Scott Horsley
Water Resources Consultant
39 Chestnut Street • Boston, MA 02108 • 508-364-7818

Re: Farm Road 40B, Sherborn, MA

Figure 1 – Area of Impact

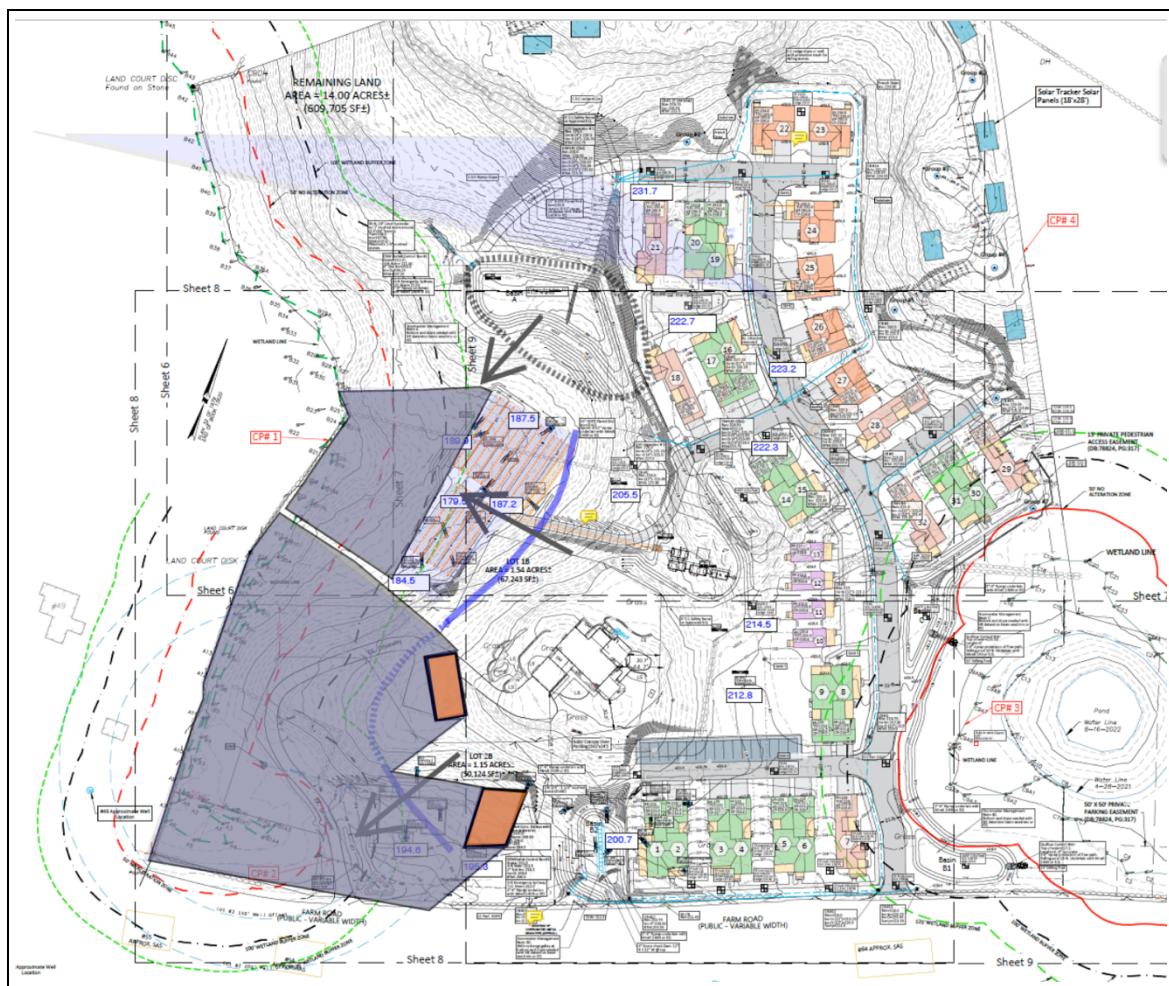
Based upon these groundwater flow directions I delineated two Areas of Impact (AOI). The northerly AOI is downgradient of the proposed 40B development septic system and the southerly AOI is downgradient of septic systems on lots 1B and 2B. The locations of

the septic systems are shown on a basemap prepared by Creative Land Development dated September 28, 2023 (see figure 1).

This analysis is provided as a preliminary / conceptual assessment. A more detailed analysis of these impacts is required by the Sherborn Board of Health Regulations and should be provided by the applicant.

The map also shows an area of probable groundwater mounding associated with the large stormwater basin to the north. This will tend to redirect the wastewater plume associated with the 40B septic system further south. Similarly, the 40B septic system will also cause considerable groundwater mounding and will alter flow directions. This groundwater mounding should be incorporated into a more definitive mapping of the Areas of Impact.
